| Job   | Truss | Truss Type  | Qty | Ply | DCI Dialysis Clinic |
| 19129 | J02   | Jack-Closed | 2   | 1   |                     |

Star Truss/Star Lumber & Supply, Wichita, Kansas

**EMC STRUCTURAL ENGINEERS, P.C.**

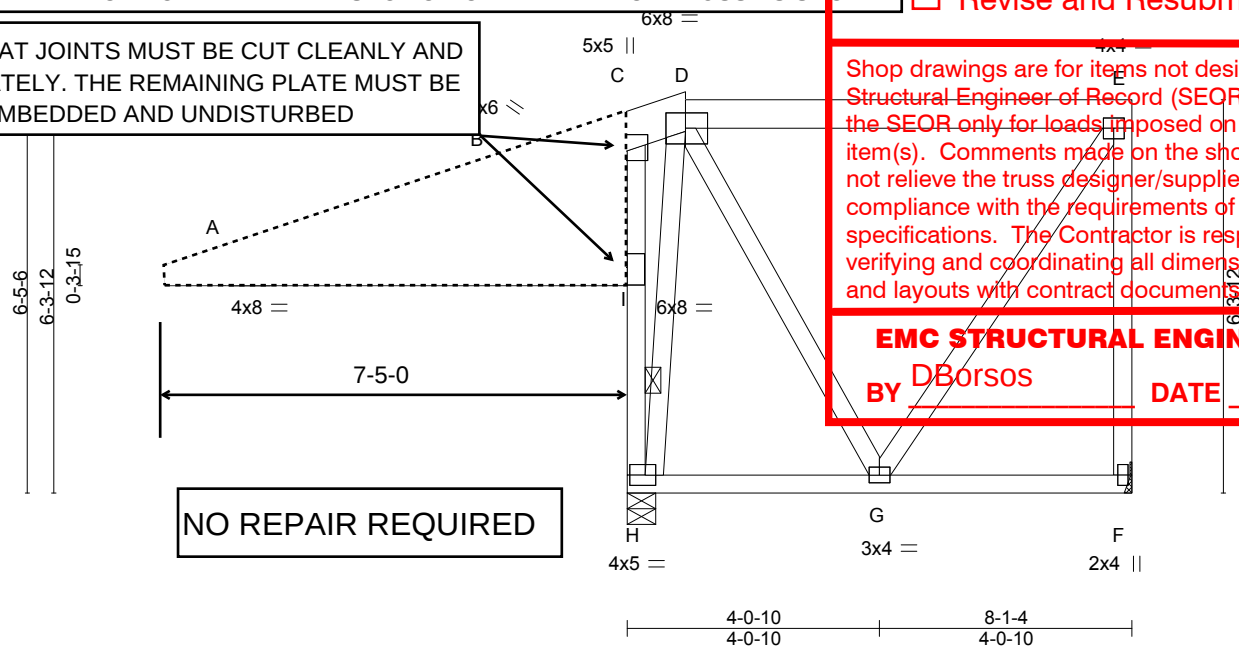
#### ALTERATION DETAIL:

- CUT AND REMOVE CANTILEVERED SECTION ON LEFT END OF TRUSS AS SHOWN.

PLATES AT JOINTS MUST BE CUT CLEANLY AND ACCURATELY. THE REMAINING PLATE MUST BE FULLY EMBEDDED AND UNDISTURBED

| 19129 | J03   | Jack-Closed | 2   | 1   |                     |

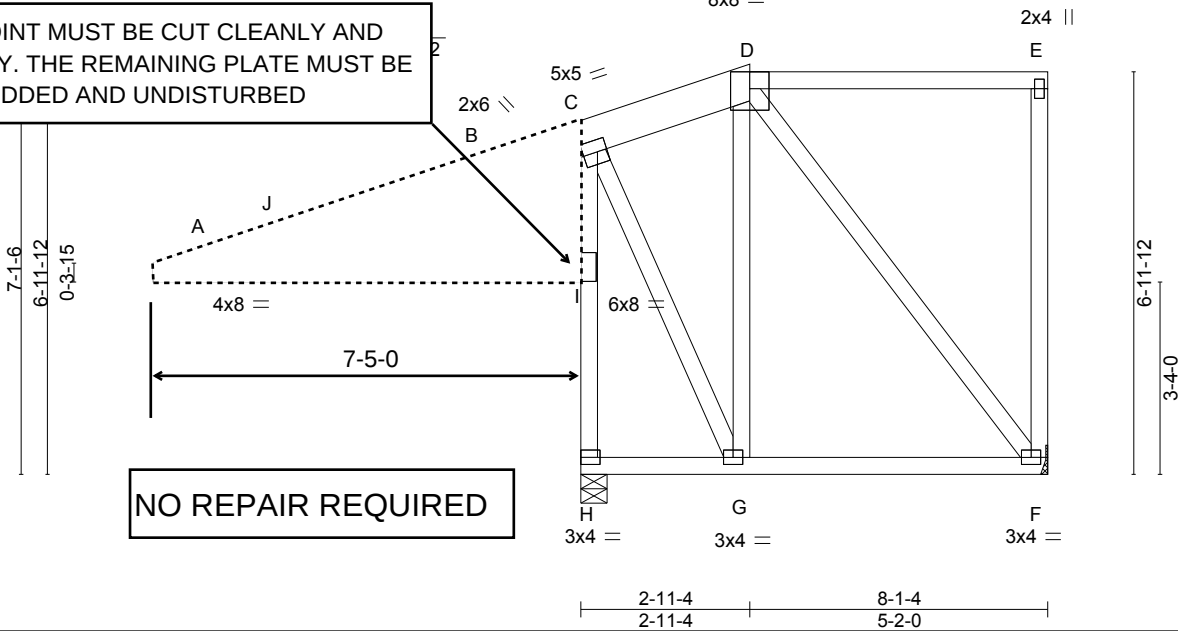
ALTERATION DETAIL:

- CUT AND REMOVE CANTILEVERED SECTION ON LEFT END OF TRUSS AS SHOWN.

PLATE AT JOINT MUST BE CUT CLEANLY AND ACCURATELY. THE REMAINING PLATE MUST BE FULLY EMBEDDED AND UNDISTURBED

NO REPAIR REQUIRED

| 19129 | J04   | Jack-Closed | 2   | 1   |                     |

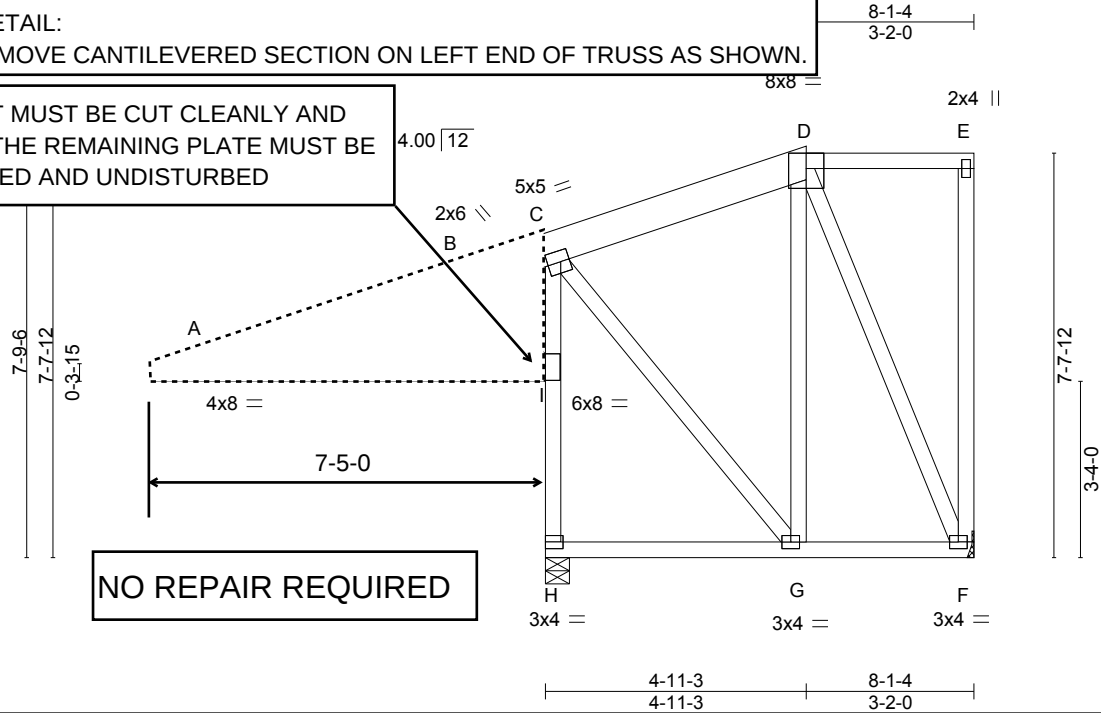
#### ALTERATION DETAIL:

- CUT AND REMOVE CANTILEVERED SECTION ON LEFT END OF TRUSS AS SHOWN.

PLATE AT JOINT MUST BE CUT CLEANLY AND ACCURATELY. THE REMAINING PLATE MUST BE FULLY EMBEDDED AND UNDISTURBED

| 19129 | J05   | Jack-Closed | 2   | 1   | Job Reference (optional) |

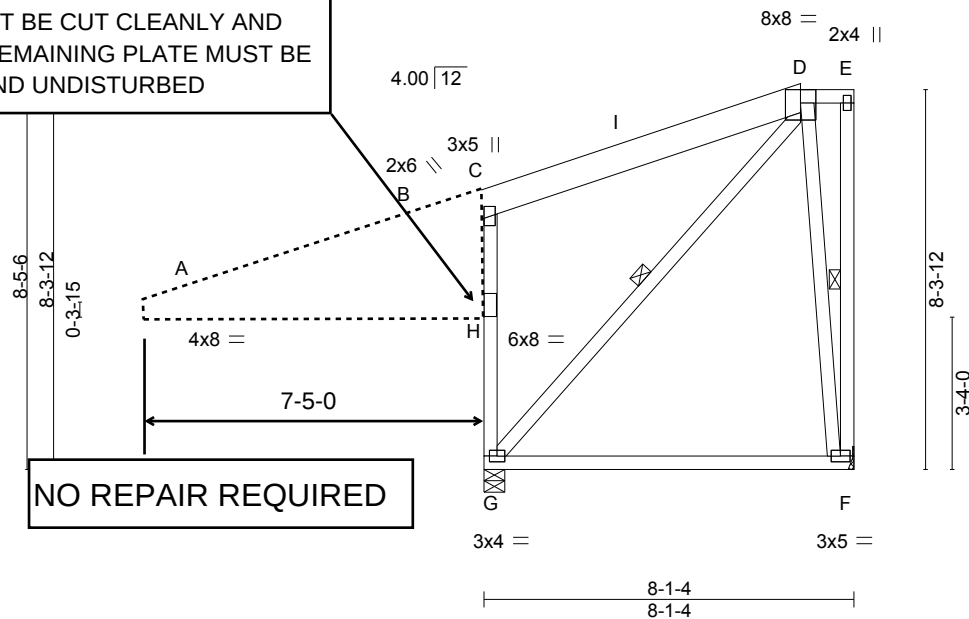
#### ALTERATION DETAIL:

- CUT AND REMOVE CANTILEVERED SECTION ON LEFT END OF TRUSS AS SHOWN.

PLATE AT JOINT MUST BE CUT CLEANLY AND ACCURATELY. THE REMAINING PLATE MUST BE FULLY EMBEDDED AND UNDISTURBED

| 19129 | J07   | Jack-Closed | 1   | 1   |                     |

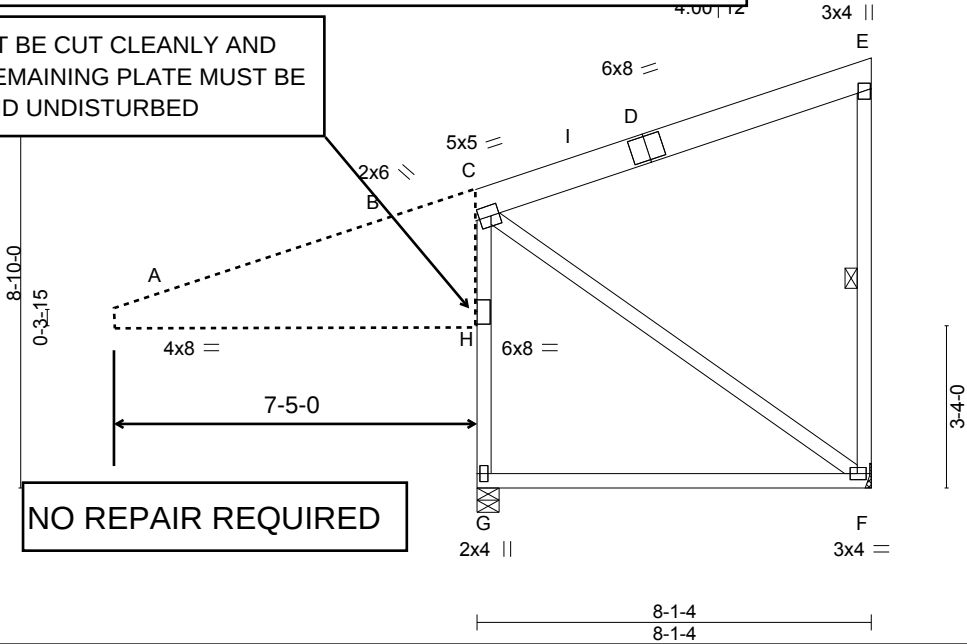
ALTERATION DETAIL:  
 - CUT AND REMOVE CANTILEVERED SECTION ON LEFT END OF TRUSS AS SHOWN.

PLATE AT JOINT MUST BE CUT CLEANLY AND ACCURATELY. THE REMAINING PLATE MUST BE FULLY EMBEDDED AND UNDISTURBED

| 19129 | T13   | Roof Special | 1   | 1   | Job Reference (optional) |

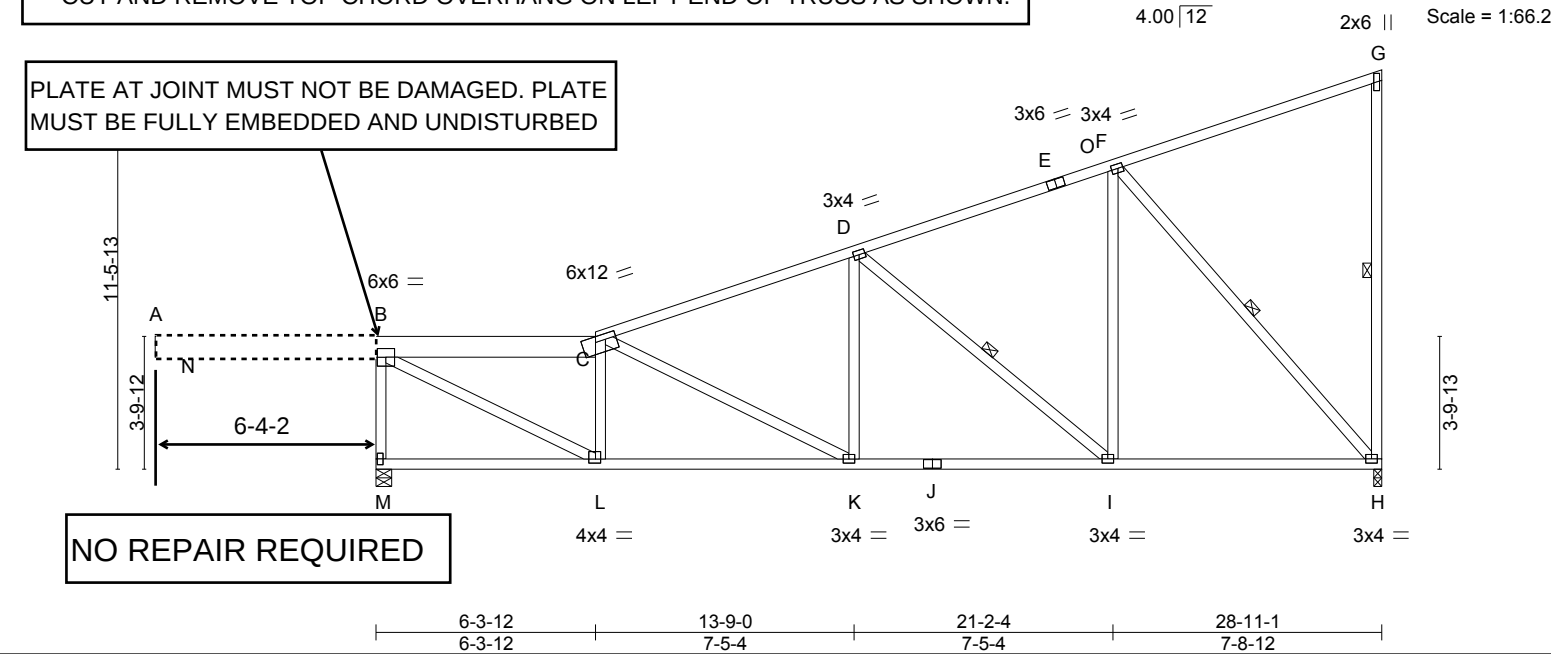
ALTERATION DETAIL:

- CUT AND REMOVE TOP CHORD OVERHANG ON LEFT END OF TRUSS AS SHOWN.

PLATE AT JOINT MUST NOT BE DAMAGED. PLATE

MUST BE FULLY EMBEDDED AND UNDISTURBED

NO REPAIR REQUIRED

| 19129 | T14   | Roof Special | 1   | 1   | Job Reference (optional) |

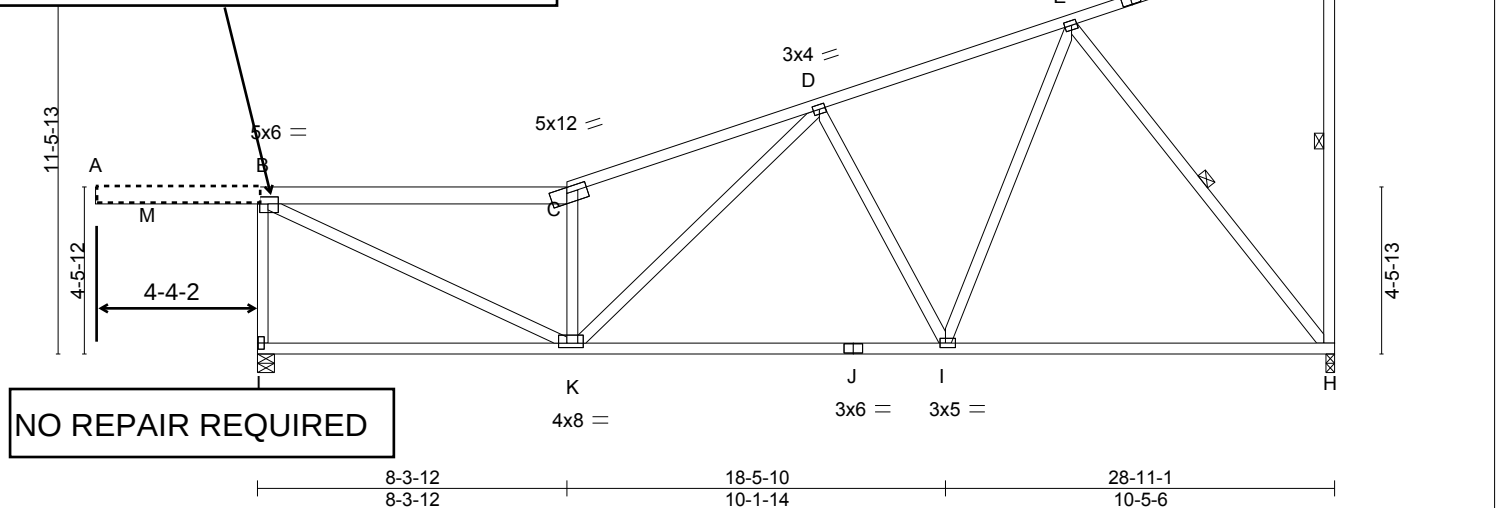
#### ALTERATION DETAIL:

- CUT AND REMOVE TOP CHORD OVERHANG ON LEFT END OF TRUSS AS SHOWN.

PLATE AT JOINT MUST NOT BE DAMAGED. PLATE MUST BE FULLY EMBEDDED AND UNDISTURBED

| 19129 | T17   | Roof Special | 2   | 1   | Job Reference (optional) |

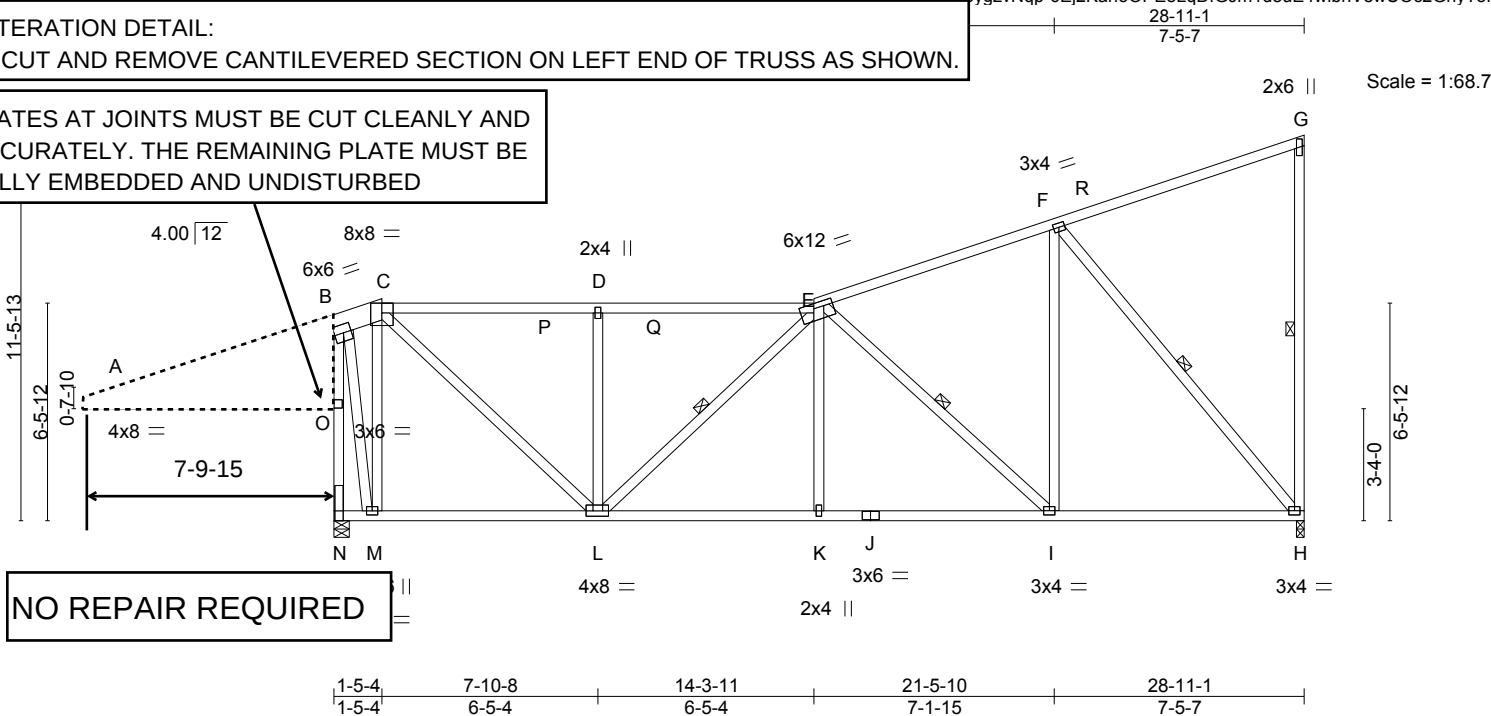
ALTERATION DETAIL:

- CUT AND REMOVE CANTILEVERED SECTION ON LEFT END OF TRUSS AS SHOWN.

PLATES AT JOINTS MUST BE CUT CLEANLY AND ACCURATELY. THE REMAINING PLATE MUST BE FULLY EMBEDDED AND UNDISTURBED

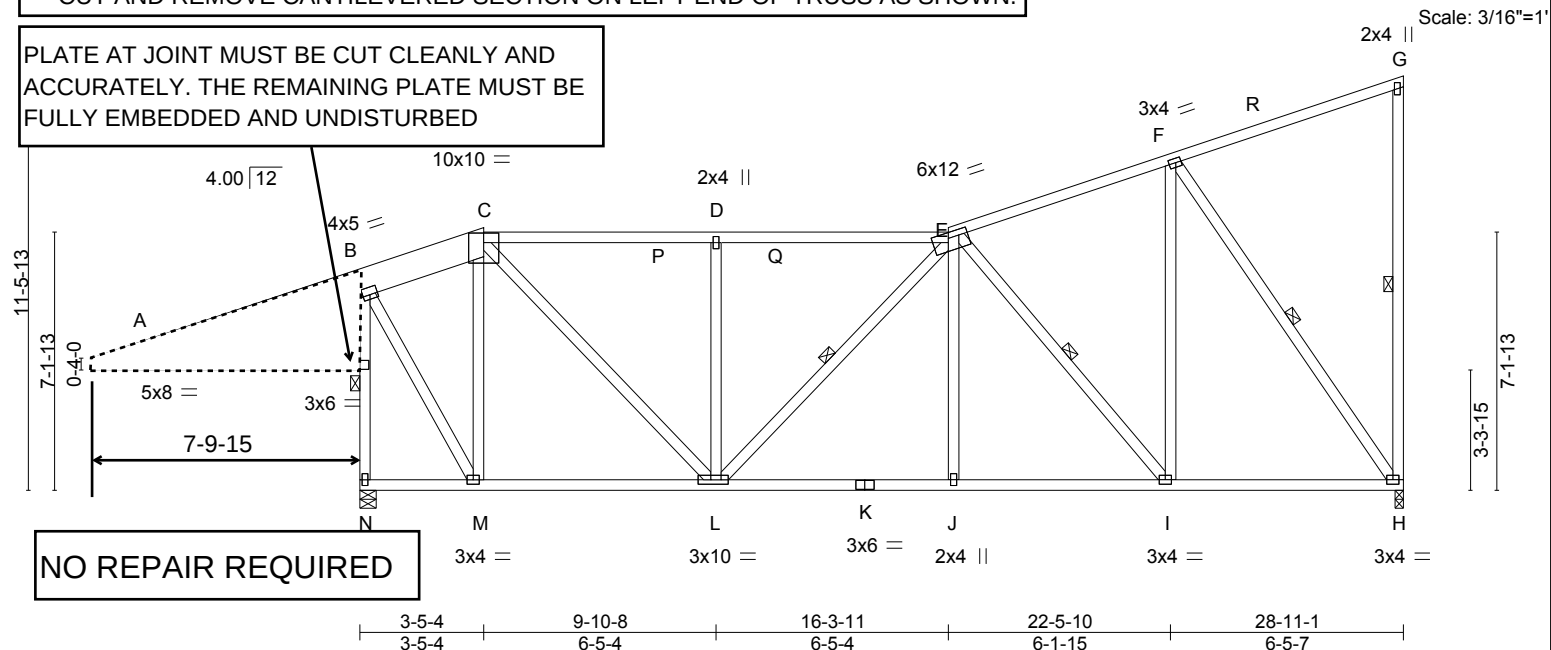
ALTERATION DETAIL:

- CUT AND REMOVE CANTILEVERED SECTION ON LEFT END OF TRUSS AS SHOWN.

PLATE AT JOINT MUST BE CUT CLEANLY AND ACCURATELY. THE REMAINING PLATE MUST BE FULLY EMBEDDED AND UNDISTURBED

| 19129 | T19   | Roof Special | 2   | 1   | Job Reference (optional) |

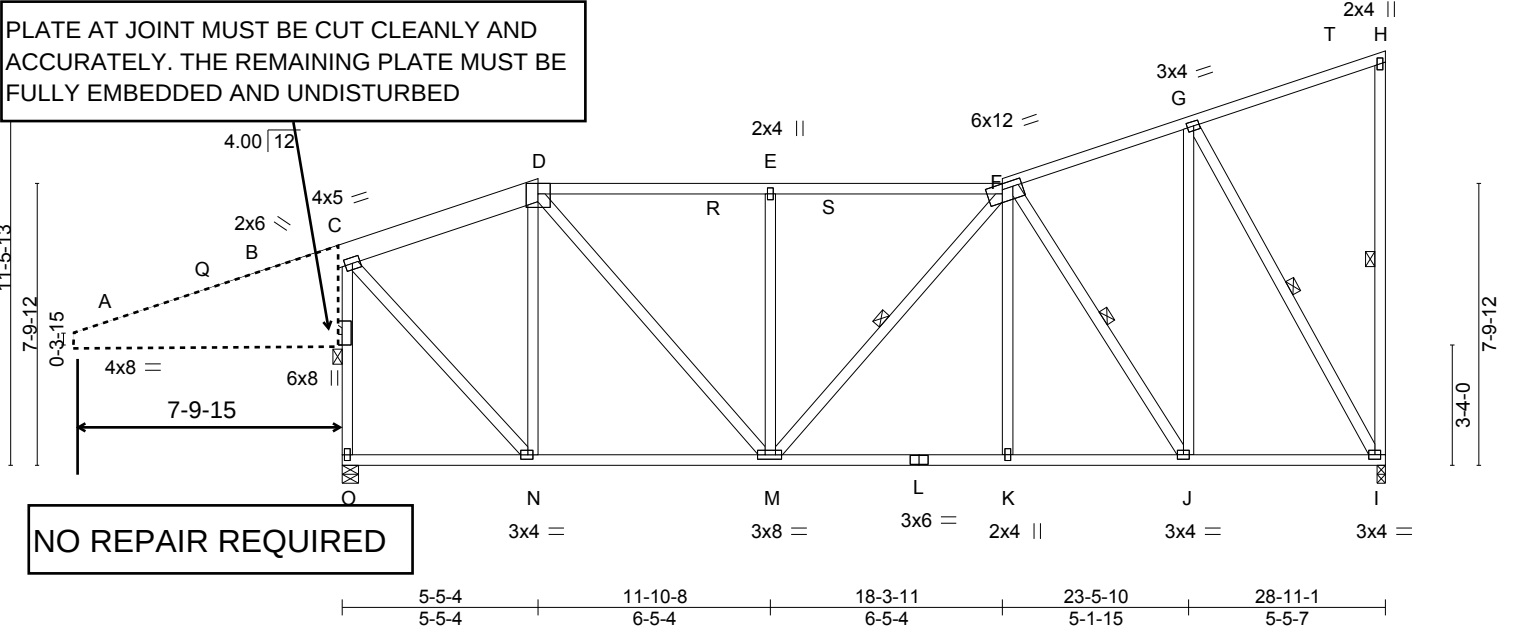
ALTERATION DETAIL:

- CUT AND REMOVE CANTILEVERED SECTION ON LEFT END OF TRUSS AS SHOWN.

PLATE AT JOINT MUST BE CUT CLEANLY AND ACCURATELY. THE REMAINING PLATE MUST BE FULLY EMBEDDED AND UNDISTURBED

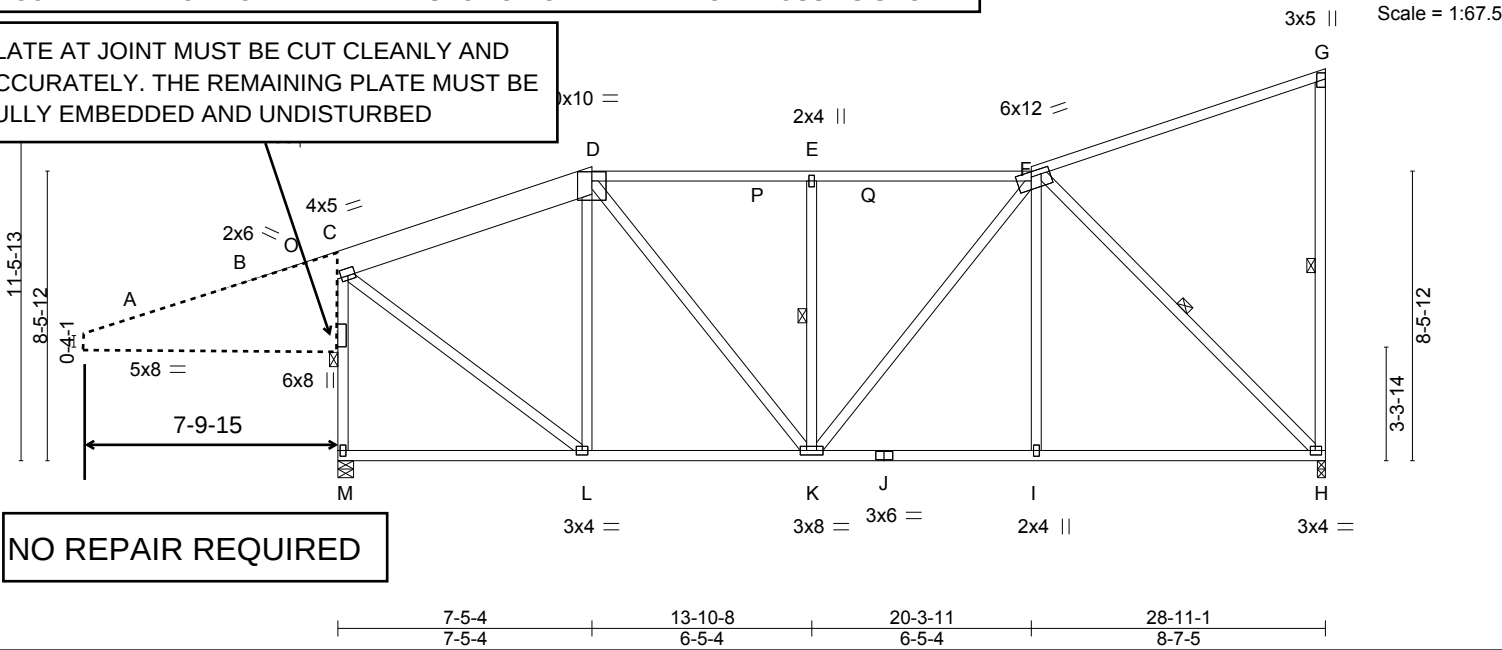
ALTERATION DETAIL:

- CUT AND REMOVE CANTILEVERED SECTION ON LEFT END OF TRUSS AS SHOWN.

PLATE AT JOINT MUST BE CUT CLEANLY AND ACCURATELY. THE REMAINING PLATE MUST BE FULLY EMBEDDED AND UNDISTURBED

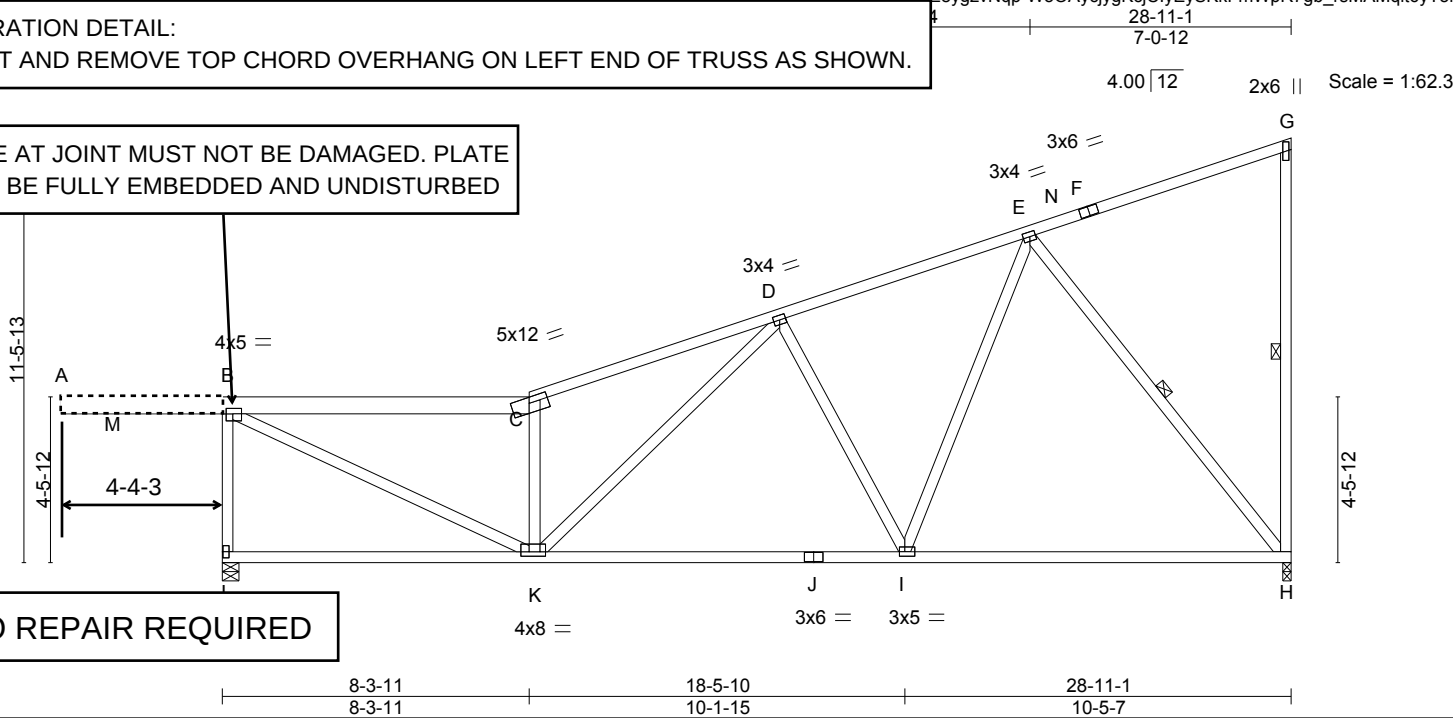
ALTERATION DETAIL:

- CUT AND REMOVE TOP CHORD OVERHANG ON LEFT END OF TRUSS AS SHOWN.

MUST BE FULLY EMBEDDED AND UNDISTURBED

NO REPAIR REQUIRED
